**WHITE LAKE TOWNSHIP
INTER-OFFICE MEMORANDUM
COMMUNITY DEVELOPMENT DEPARTMENT**

**SUBJECT: Panera
Preliminary site plan approval**
Property described as parcel number 12-20-276-035, located north of Highland Road (M-59), west of Bogie Lake Road, southeast of Meijer consisting of approximately 1.63 acres.

RE: Panera Bread and Retail Development- Preliminary Site Plan Review – 3rd Review

RE: Panera Bread
Preliminary Site Plan – Review #3

ALTA / NSPS LAND TITLE SURVEY
PREPARED FOR: ALRIG USA
HIGHLAND RD, WHITE LAKE, MICHIGAN,
PART OF SECTION 20,
TOWN 3 NORTH, RANGE 8 EAST

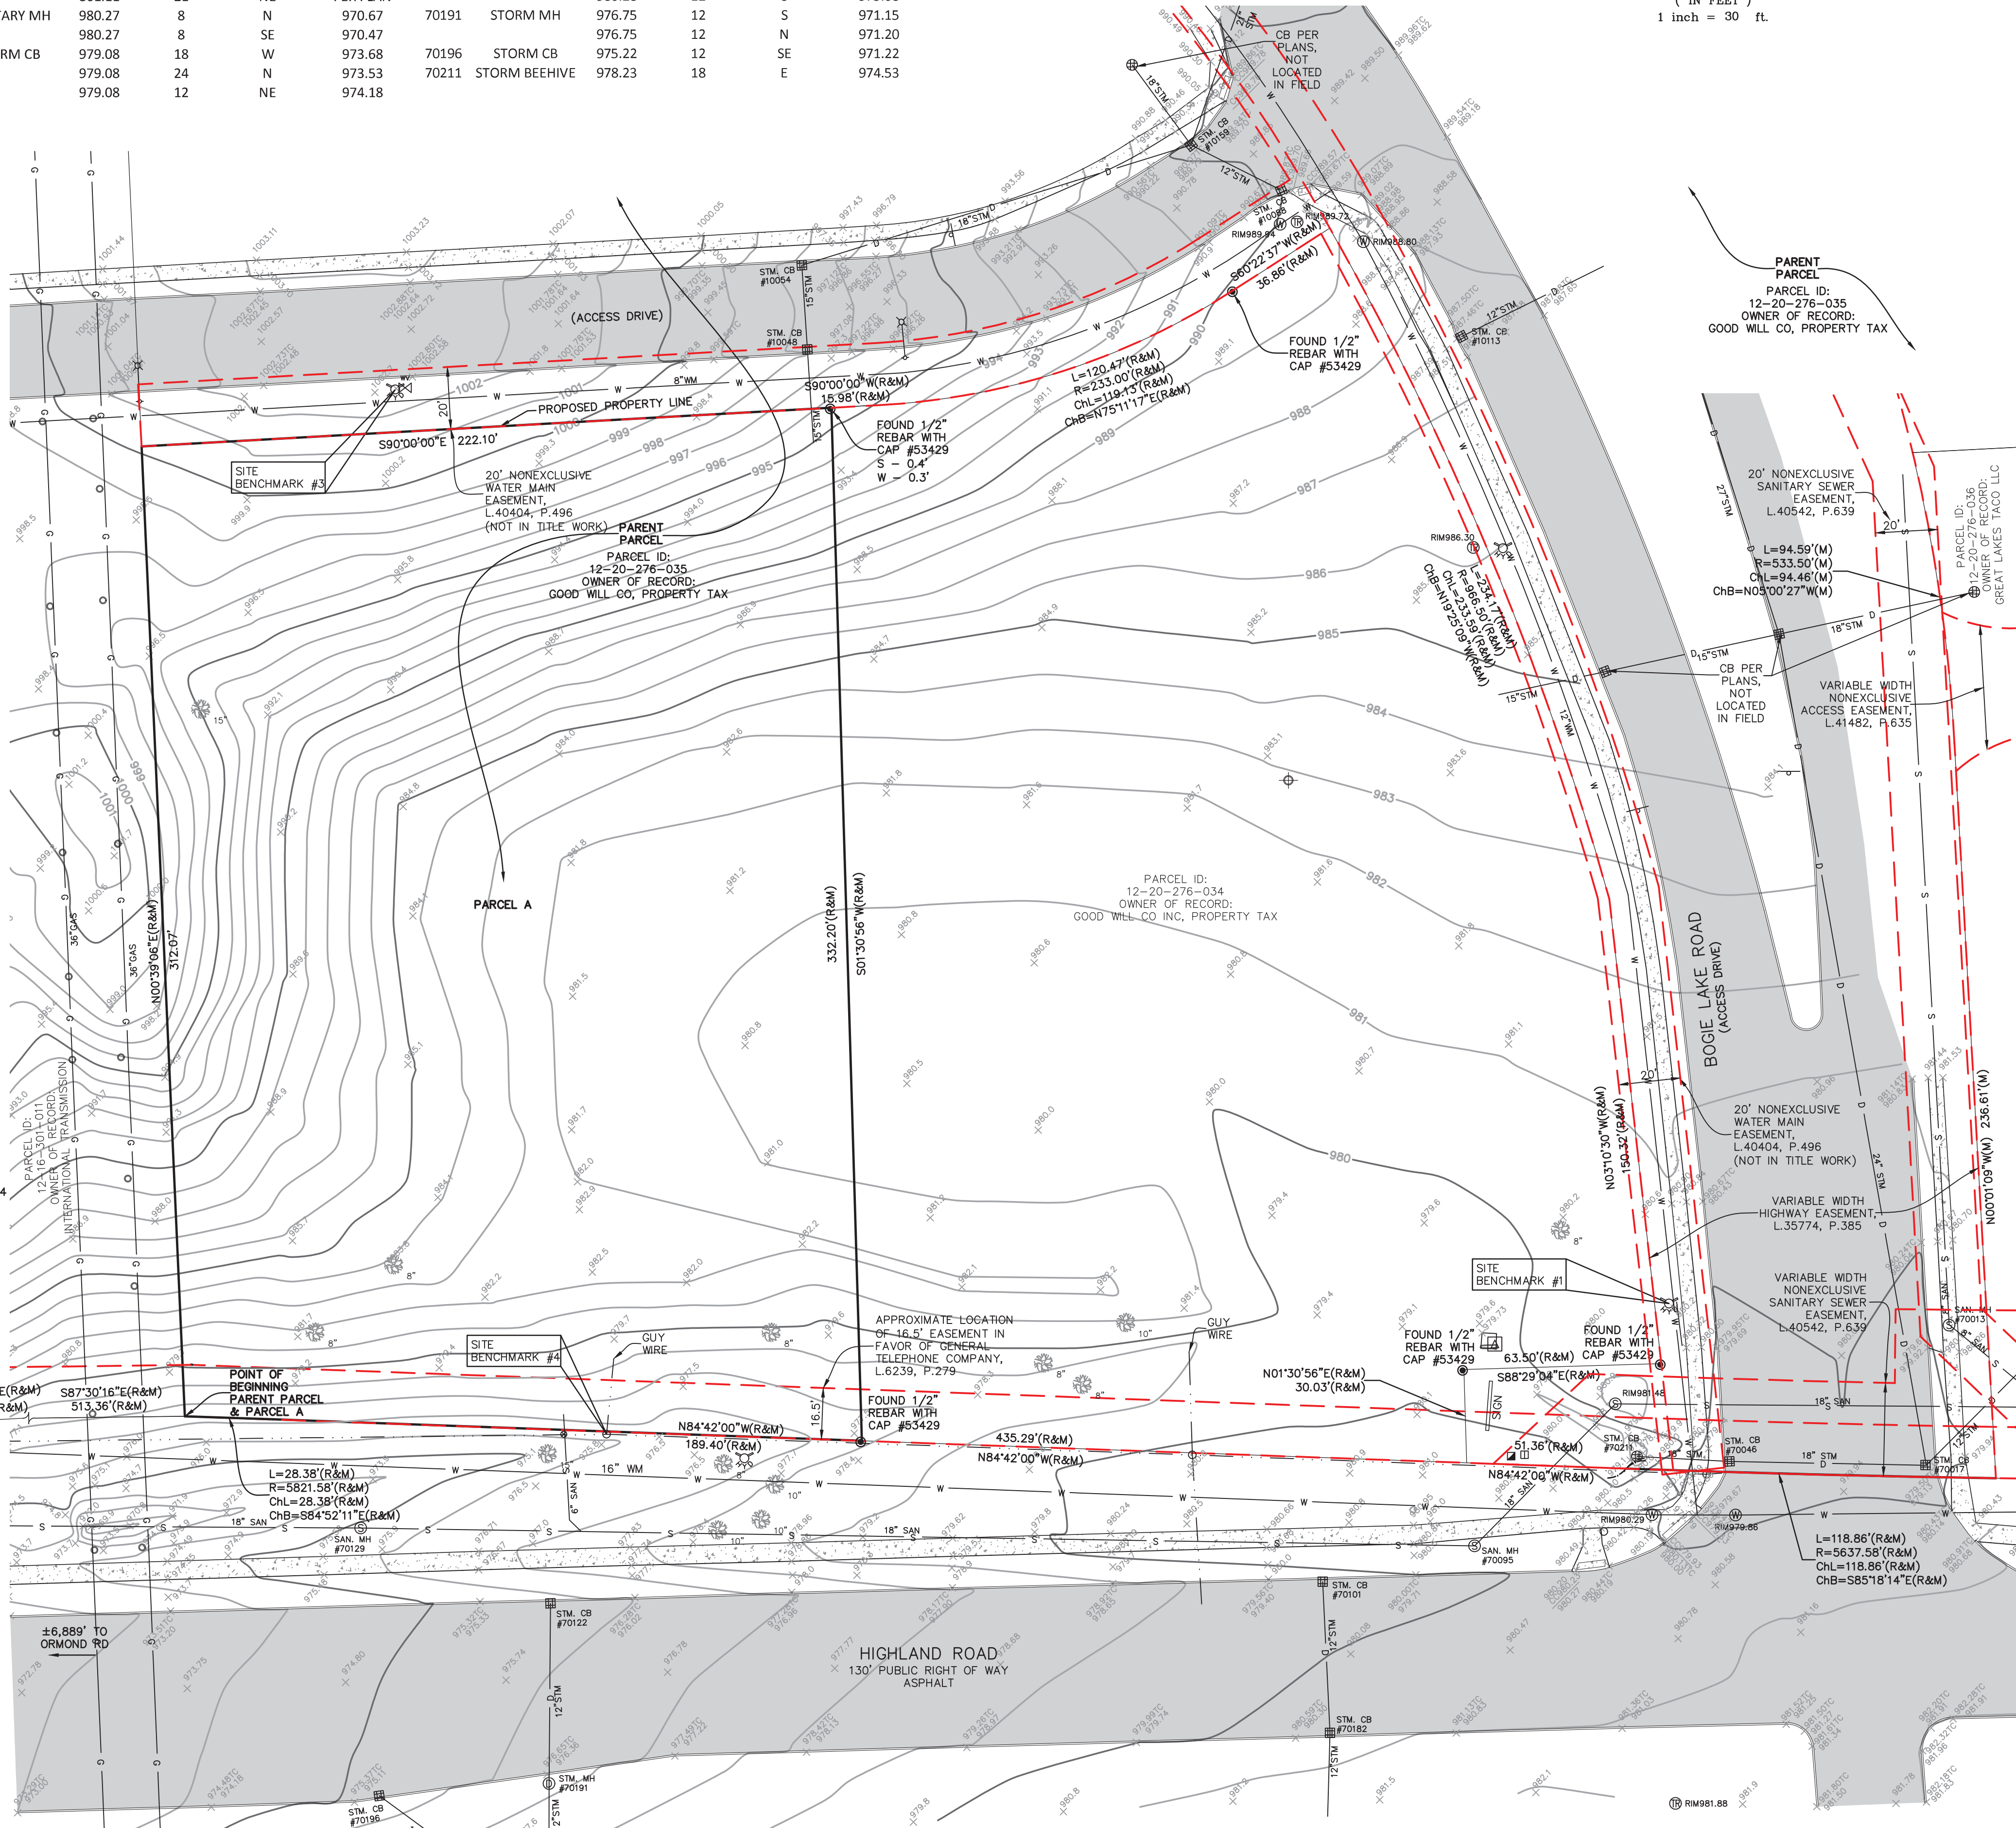
- a) *The ALTA survey shows the existing storm sewer in the Meijer Drive as 12" diameter which is incorrect per Meijer Storm Sewer A/B plan dated 02/21/2006 (shown as 15" diameter); revise all existing storm sewer in Meijer Drive on the ALTA survey and all relevant plan sheets to reflect the correct pipe sizes. Comment partially addressed. A copy of the Meijer storm sewer plan has been attached. Please update the pipe size. **Comment addressed. Existing storm sewer diameter has been corrected.***

Project Number: 230094
Sheet Number: A200
Issue Date: XX.XX.XX
DPM: DM CPM: CPM

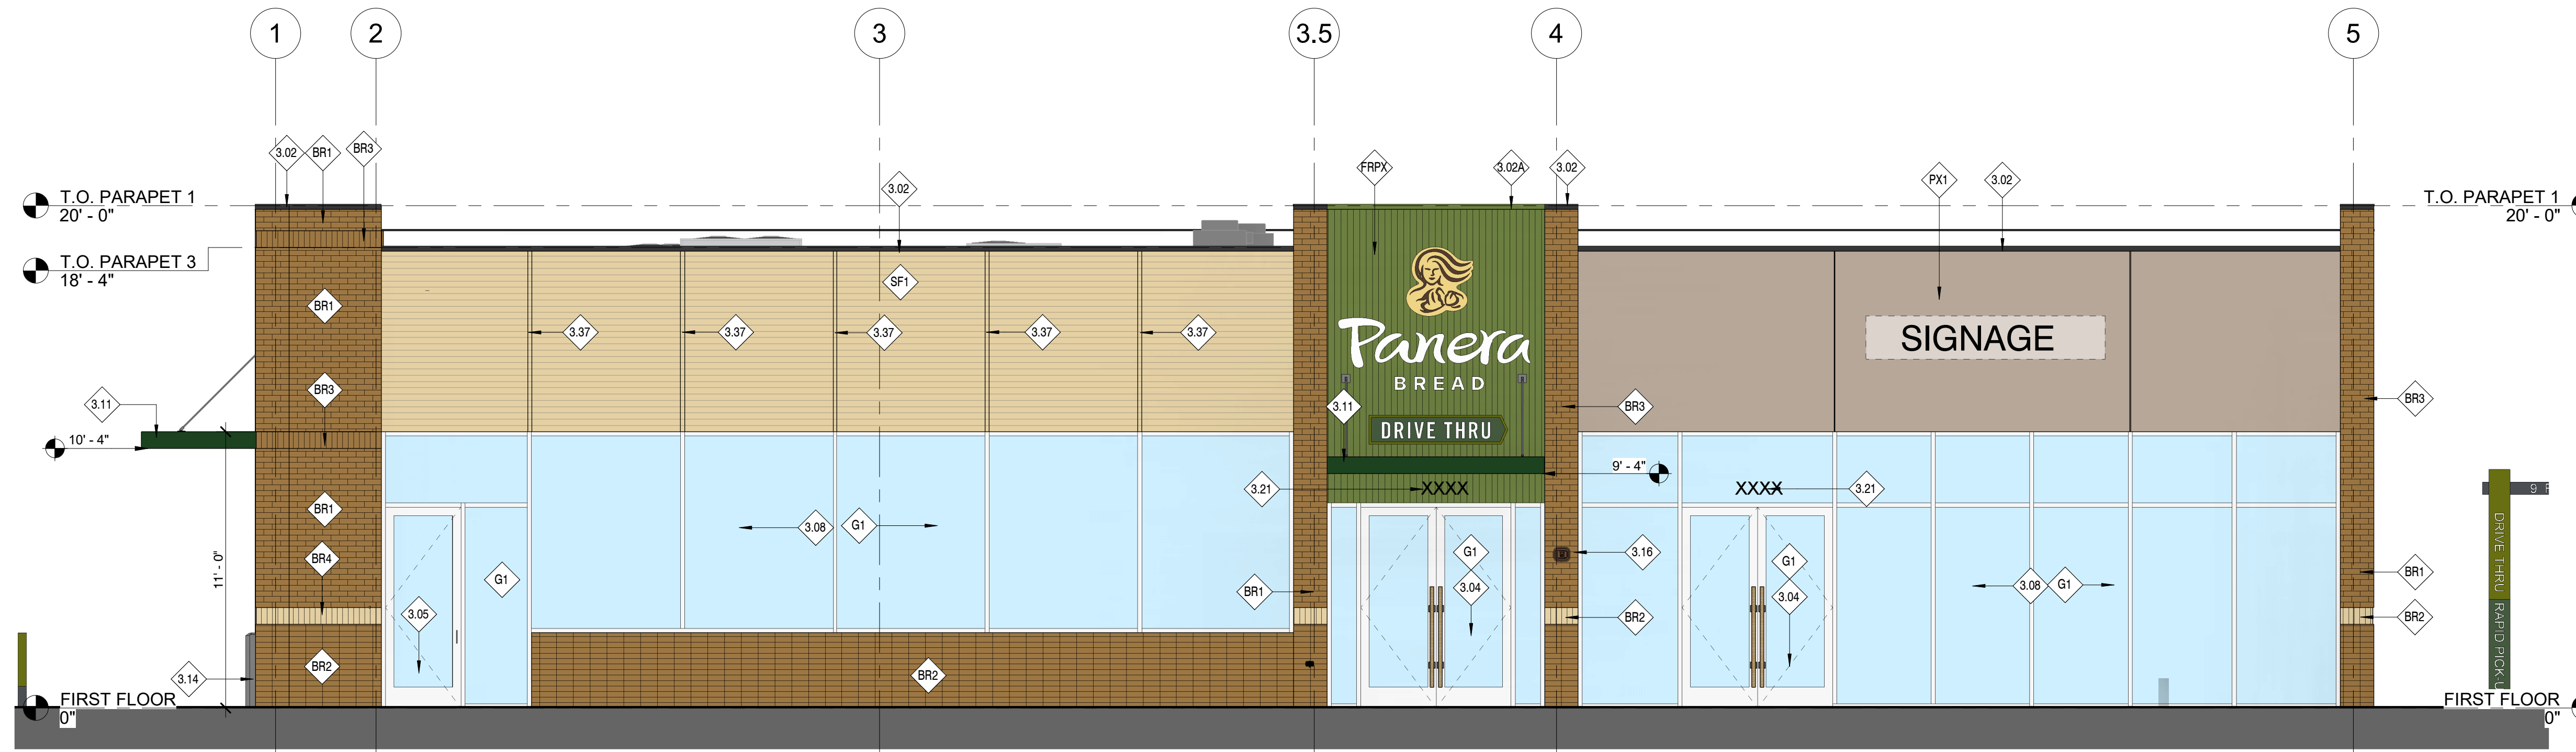
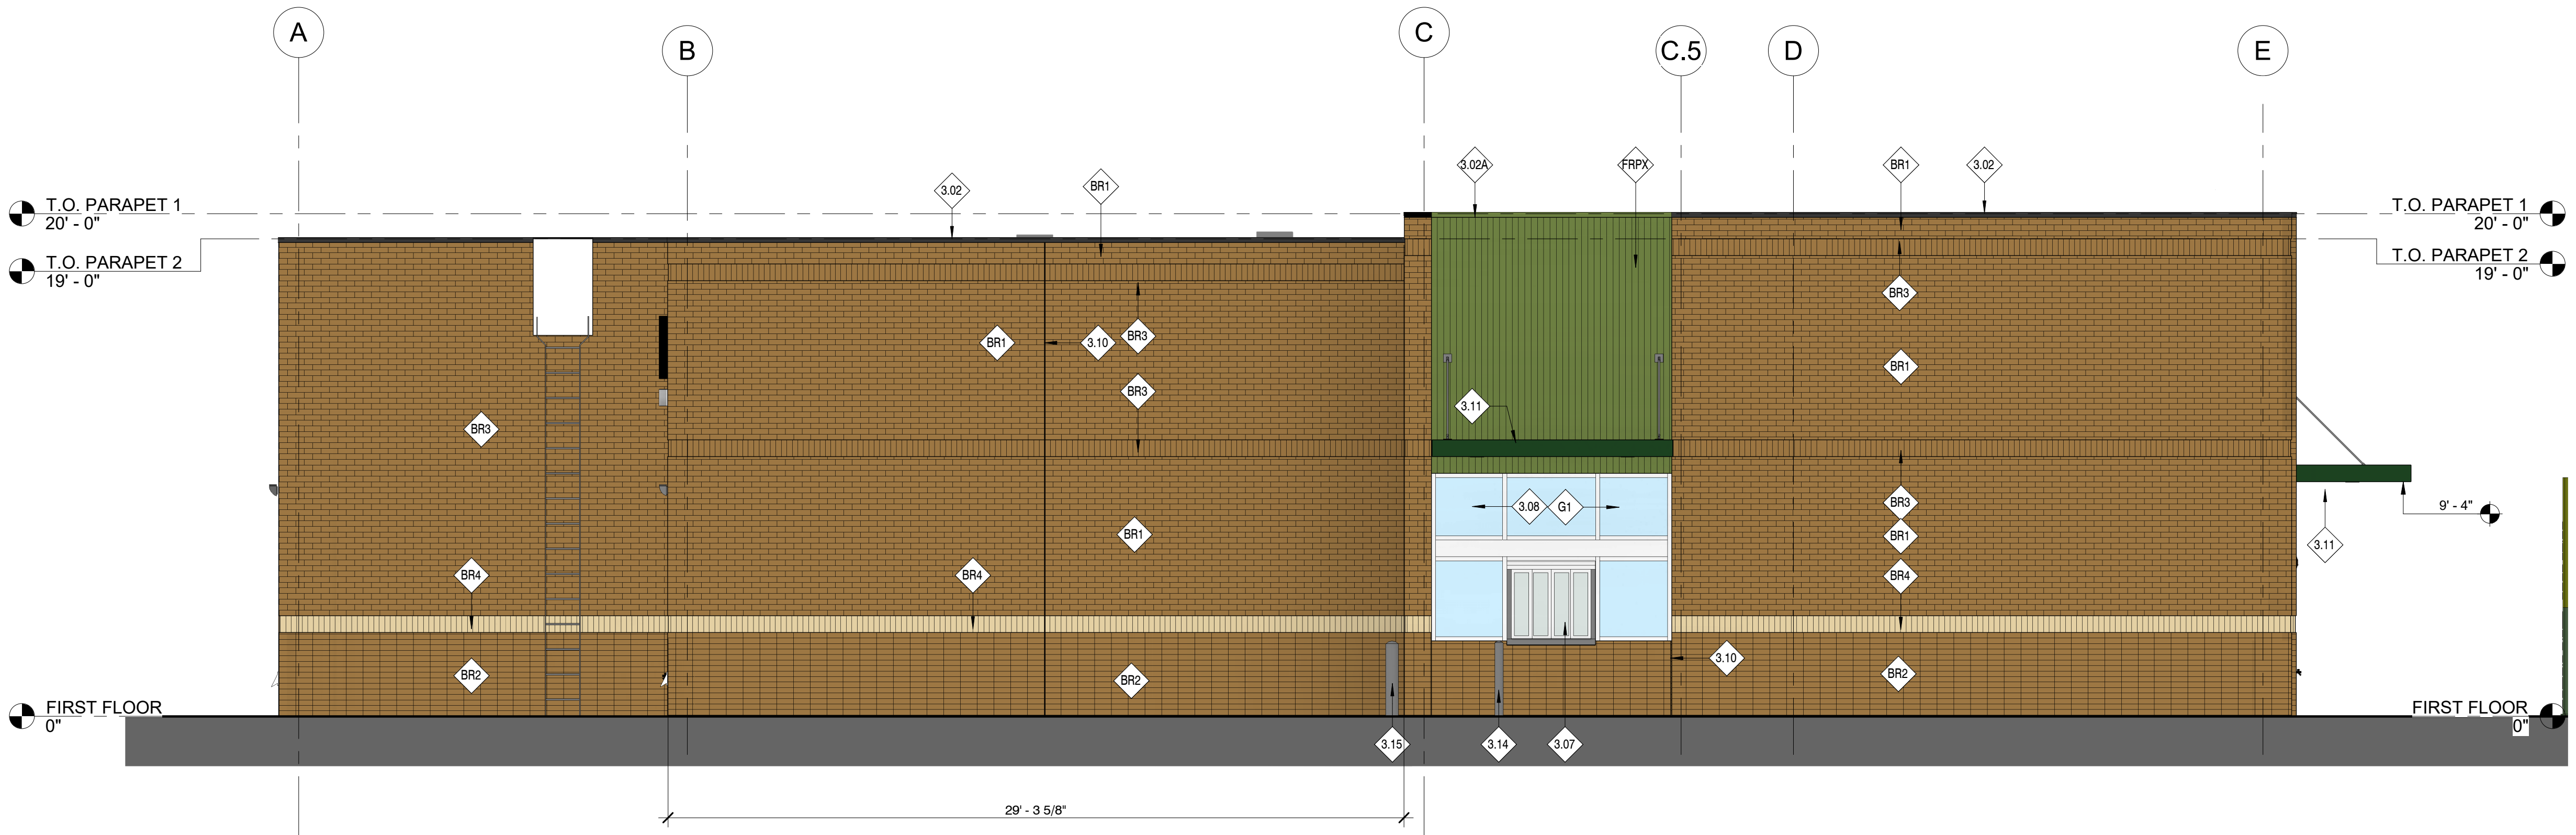
In accordance with the M-59 architectural character requirements, exterior building materials shall be comprised primarily of high quality, durable, low maintenance material, such as masonry, stone, brick, glass, or equivalent materials. Buildings should be completed on all sides with acceptable materials **consideration shall be given to the north facade design as it would be visible from a street. The north facade shall resemble a front facade, not a rear facade).** (Comment addressed. The north facade is now comprised of brick veneer with spandrel glazing to give the appearance of windows). The proposed materials for the 19-foot-tall building are a mix of EFIS (exterior insulation finishing system), aluminum wood-look cladding system, brick veneer, and fiberglass panels. **The building materials do not meet the architectural requirements of the Township, and the building is not designed to create a pleasing appearance. Aluminum cladding, EFIS, and fiberglass panels are not considered high-quality materials. Seventy (70) percent of all elevations of the building should be covered with some type of brick or cultured stone product.** (Comment addressed. The north, east, and west facades of the building are now primarily covered with brick veneer, and the north facade contains increased window coverage (the EIFS remains undesirable)).

Sheets A200, A201, and A101 reference sheets not provided in the plan set – provide the referenced sheets or remove references to sheets not provided. (Comment addressed. References to sheets not provided in the plan set have been removed).
